31/6-96K 3714 Washington Street
(Kensington Historic District)

SUBJECT: Historic Area Work Permit

HISTORIC PRESERVATION COMMISSION STAFF REPORT

Case Number: 31/6-96K (CONTINUED)

Proposed Site Plan Tree Locations
3714 Washington St. Kensington MD

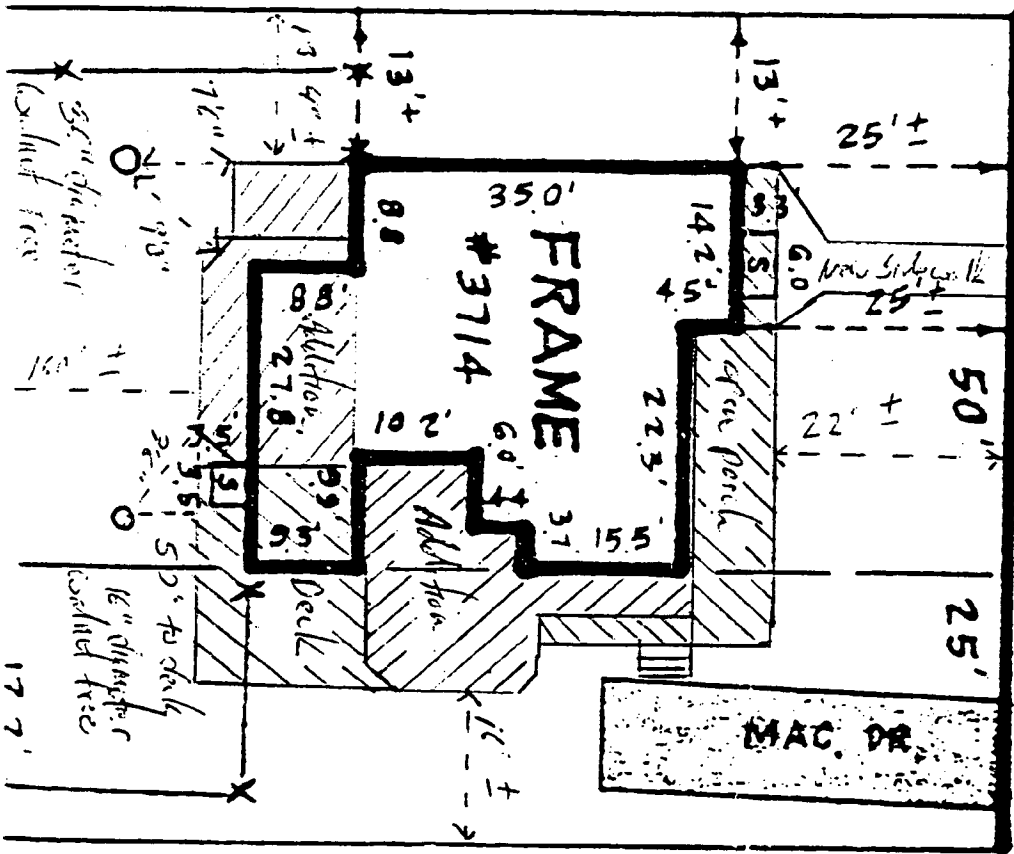
- 1) certified arborist & a staff arborist (2) to confirm in writing piers & foundation walls are outside CRZ (Critical Root Zone) of the 36" & 16" black walnut trees in backyard.
- 2) Adequate & effective tree protection including barrier fencing at tree driplines developed & enforced thruout construction period.
- 3) English boxwood in front yard moved to back or side yards.
- 4) fencing removed for construction will be replaced w/ fencing in kind.

NORTH ELEVATION

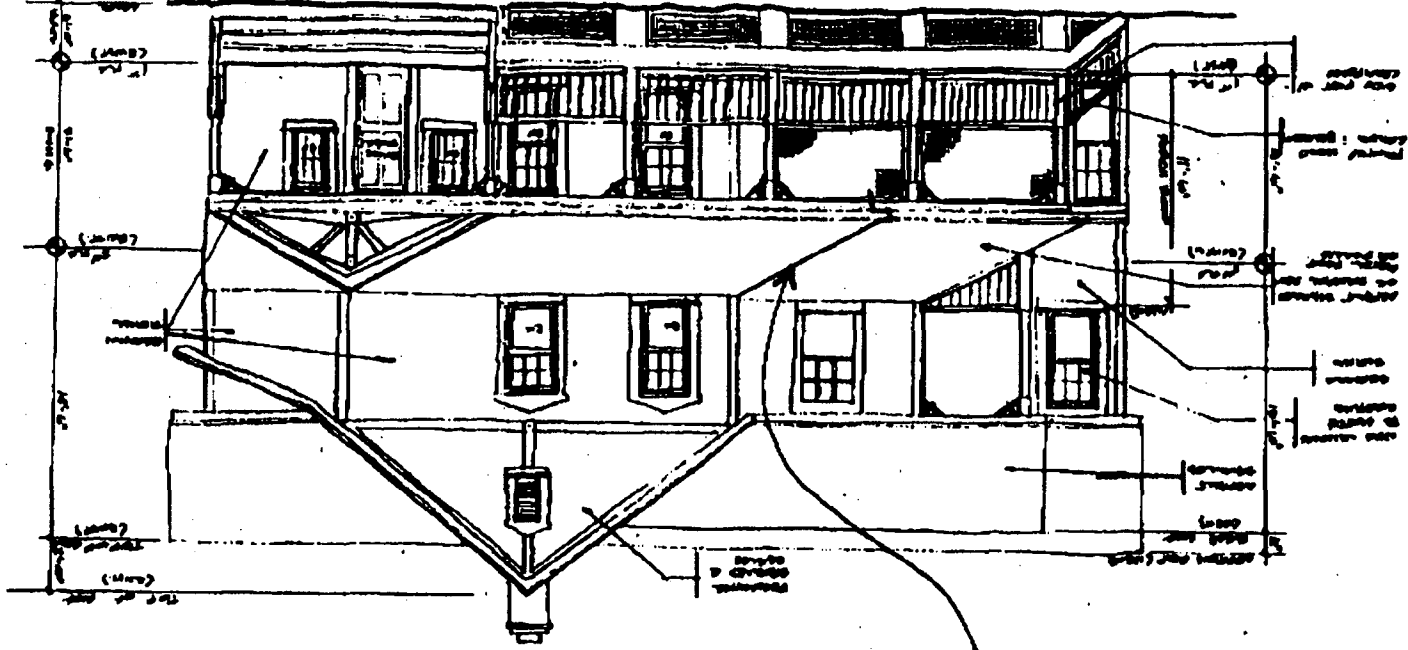
Having expressed this, we believe that stepping back the massing at the front of the house would greatly mitigate our concerns. (See attached facade drawing.) We propose that the addition be pushed back another foot or so from the plane of the original front facade, and that the porch roof step back accordingly, at the joint between original house and addition, in order to clearly delineate old from new, and to better preserve the relationship of the house to the rhythm of the existing streetscape. The plan of the house would not have to be altered drastically to achieve this, and the relationship of the house to the streetscape would be greatly improved.

PROPOSED STEP-BACK
OF PORCH ROOF
